Access Compliance Report

Public Rights-of-Way

(Curb Ramps)

Intersection ID: 50603	Main Street: RHODORA_RD	Cross Street: EMPRESS_CT	Location: SE
ADA ID: 3E3345FB31E6	Ramp Type: Perp	Initial Pass/Fail: Fail	Overall Compliance: No
Severity Score: 10			
Codes/Mitigation Info/Possible Solution		Field Measurements/Component Compliance

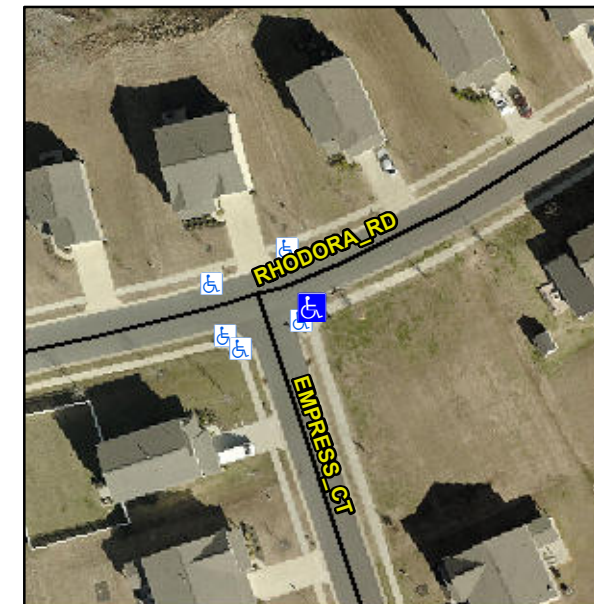
Not Found, R304.5.1, R304.5.3

Compliance	Description	Data	Compliance	Description	Data
N/A	Ramp Length (in)	47.5	Yes	Ramp Slope (%)	7.4
No	Ramp Width (in)	47.0	No	Ramp XSlope (%)	3.1
N/A	Flare Type LT	N/A	N/A	Flare Type RT	N/A
N/A	Flare Slope LT (%)	N/A	N/A	Flare Slope RT (%)	N/A
N/A	Flare Traversable LT?	N/A	N/A	Flare Traversable RT?	N/A
N/A	Landing Length (in)	N/A	N/A	DWS Provided?	N/A
N/A	Landing Width (in)	N/A	N/A	DWS Contrast?	N/A
N/A	Landing Slope (%)	N/A	N/A	DWS Length (in)	N/A
N/A	Landing X Slope (%)	N/A	N/A	DWS Full Width?	N/A
N/A	Landing Curb? (Y/N)	N/A	N/A	DWS Offset (in)	N/A
N/A	Shared Landing?	N/A			
N/A	Gutter Ponding?	N/A	N/A	Gutter Slope (%)	N/A
N/A	Gutter Lip Ht (in)	1.0	N/A	Gutter X Slope (%)	N/A
N/A	Painted X Walk1?	No	N/A	Painted X Walk2?	N/A
	X Walk 1 Direction	To N		X Walk 2 Direction	N/A
N/A	X Walk 1 Width (in)	N/A	N/A	X Walk 2 Width (in)	N/A
	X Walk 1 Slope (%)	1.4		X Walk 2 Slope (%)	N/A
	X Walk 1 X Slope (%)	2.7		X Walk 2 X Slope (%)	N/A

Remove & Replace Entire Ramp.
